**Project: IEEE P802.15 Working Group for Wireless Personal Area Networks
(WPANs)**

Submission Title: VLC cell mobility clarification

Abstract: proposes clarification for the VLC cell mobility concept

Figure 3—VPAN device architecture

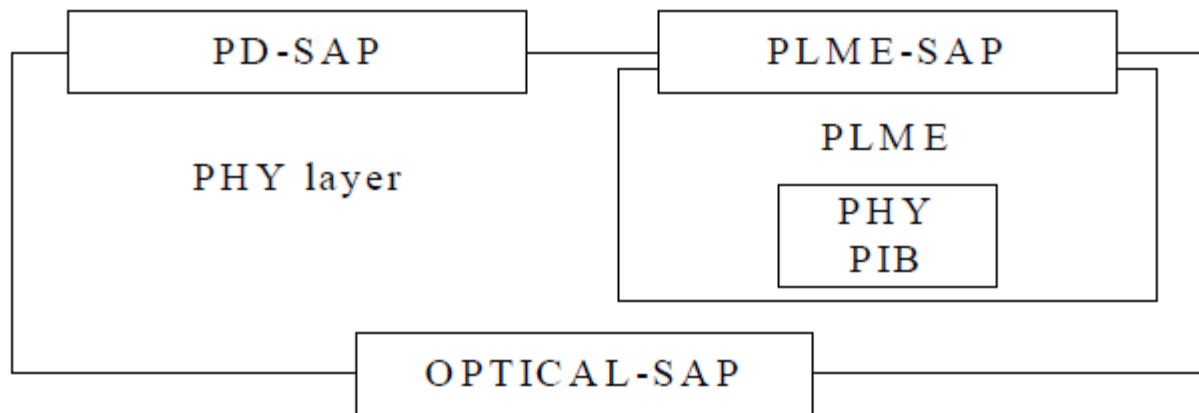
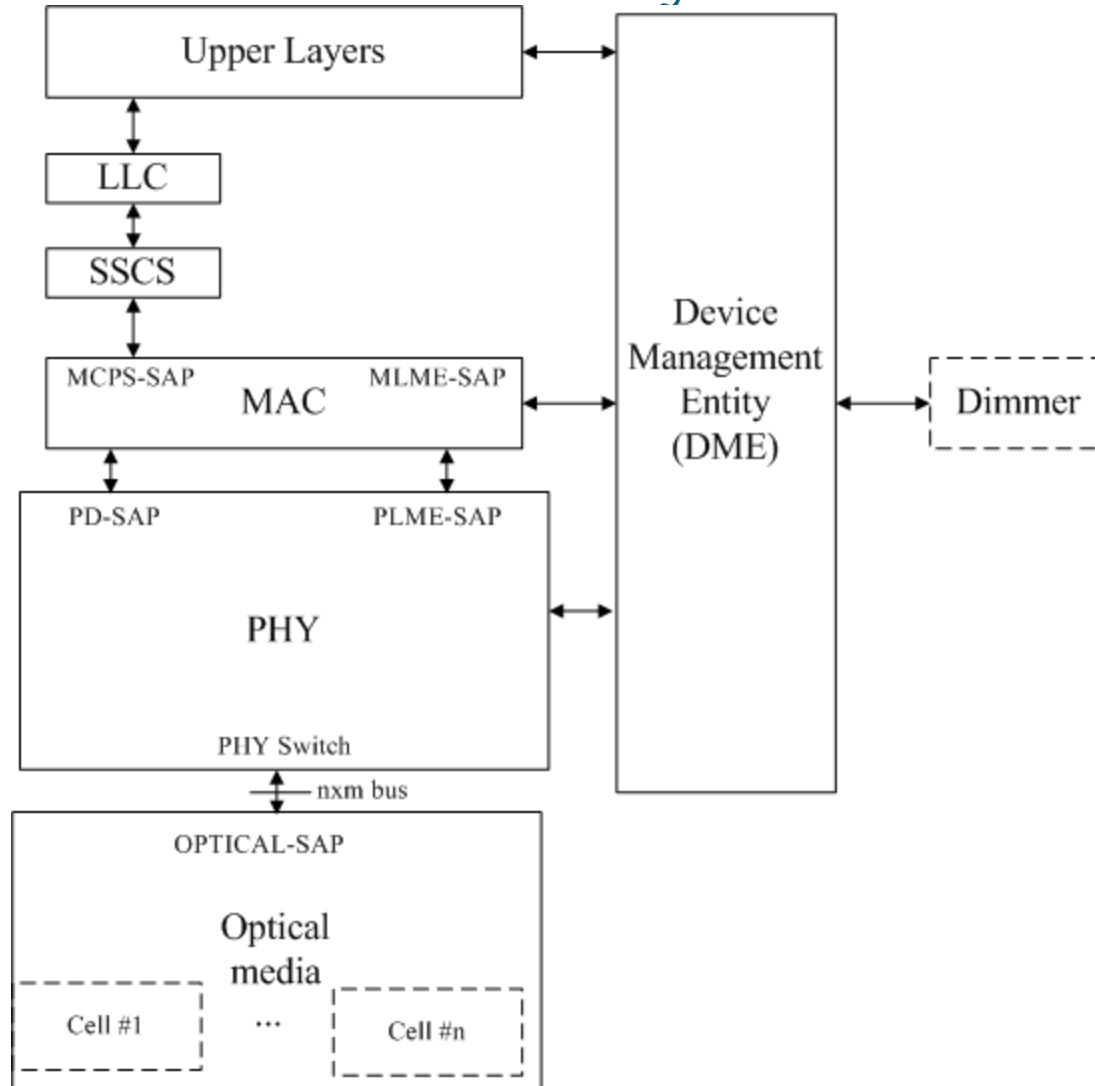
Current text for architecture

A VPAN device comprises of a PHY layer, which contains the light transceiver along with its low-level control mechanism, and a MAC sublayer that provides access to the physical channel for all types of transfers. Figure 3 shows these layers in a graphical representation, which are described in more detail in 4.4.1 and 4.4.2.

The upper layers, shown in Figure 3, consist of a network layer, which provides network configuration, manipulation, and message routing, and an application layer, which provides the intended function of the device. The definition of these upper layers is outside the scope of this standard. A logical link control layer (LLC) can access the MAC sublayer through the service-specific convergence sublayer (SSCS), defined in Annex C.

Agreed direction for PHY architecture

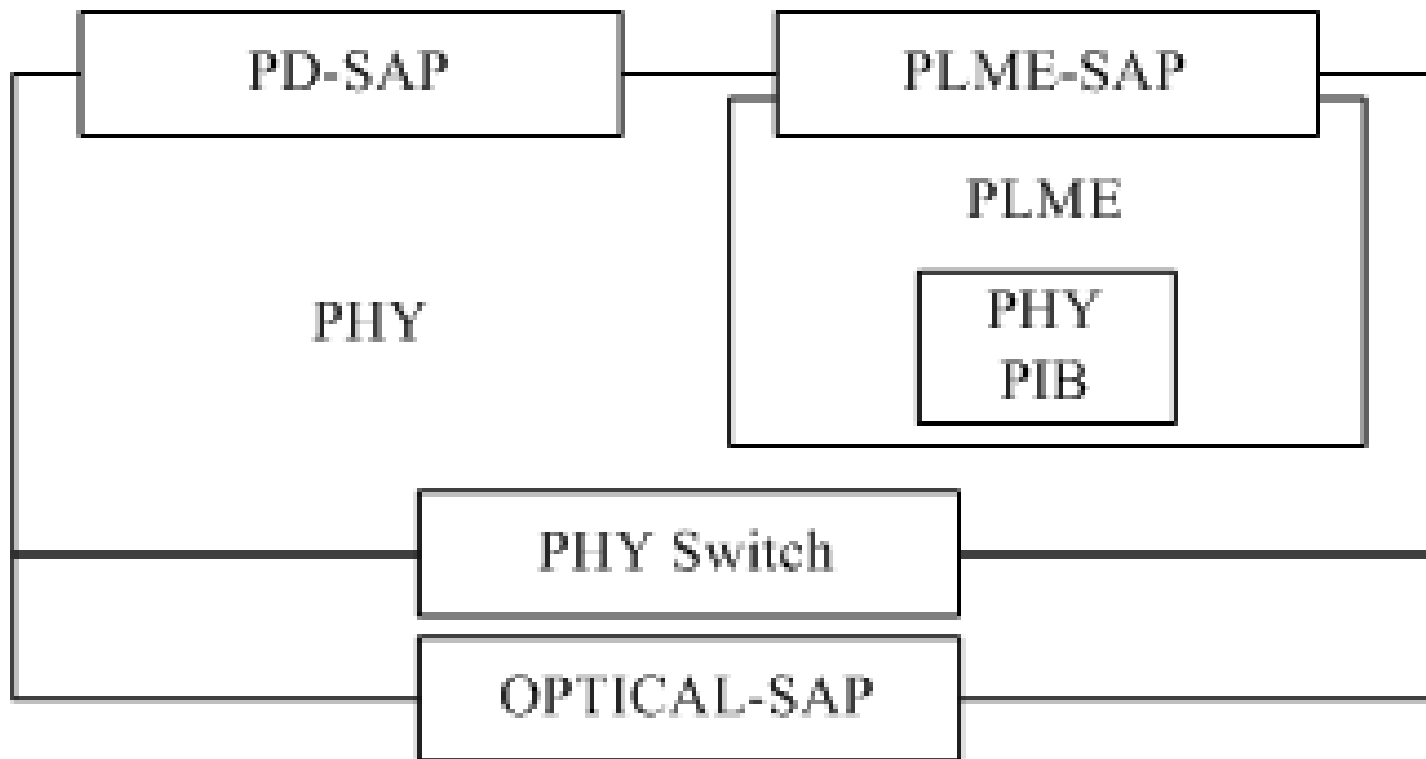
Add text – PHY Switch definition

Add PHY Switch description to document

PHY Switch

- provides a transmission interface between the PHY and the optical SAP and is used to send and receive data to and from a single or multiple optical sources and photodetectors in a selective manner.

Add text – optical media

The PHY switch interfaces to the optical SAP and connects to the optical media, which may consist of a single or multiple optical sources and photodetectors. Multiple optical sources and photodetectors are supported in the standard for PHY III as well for VLC cell mobility. The PLME controls the PHY switch in order to select a cell, defined as a group of optical sources and photodetectors.

PLME-SWITCH

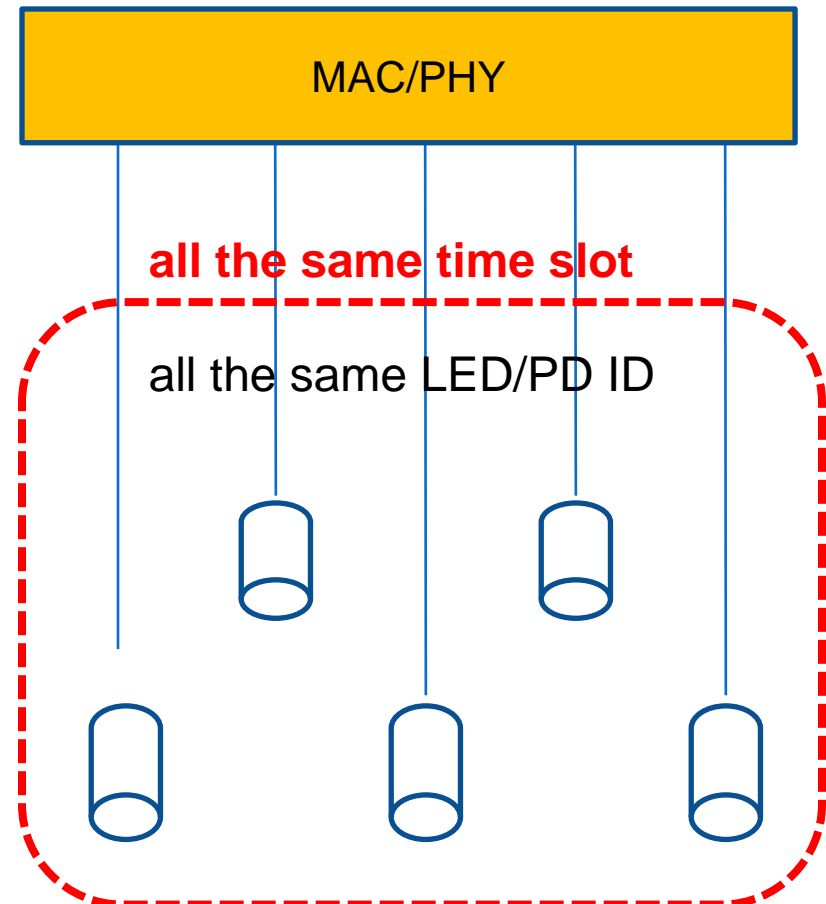
PLME-SWITCH(SW-BIT-MAP, DIR);

- DIR selects the switch direction based on TX or RX
- SW-BIT-MAP is a vector containing 'n'x'm' entries, one bit for each optical source or photodetector and is dependent on the direction. Setting the kth bit to a "1" brings the corresponding optical source or photodetector into the cell group.
- The value of 'n' is obtained from the PHY PIB table (Table 24) and would be fetched and entered using the normal GET/SET PHY PIB primitives, shown in subclause 5.2.2.
- 'm' is 1 for PHY I, II and 3 for PHY III.
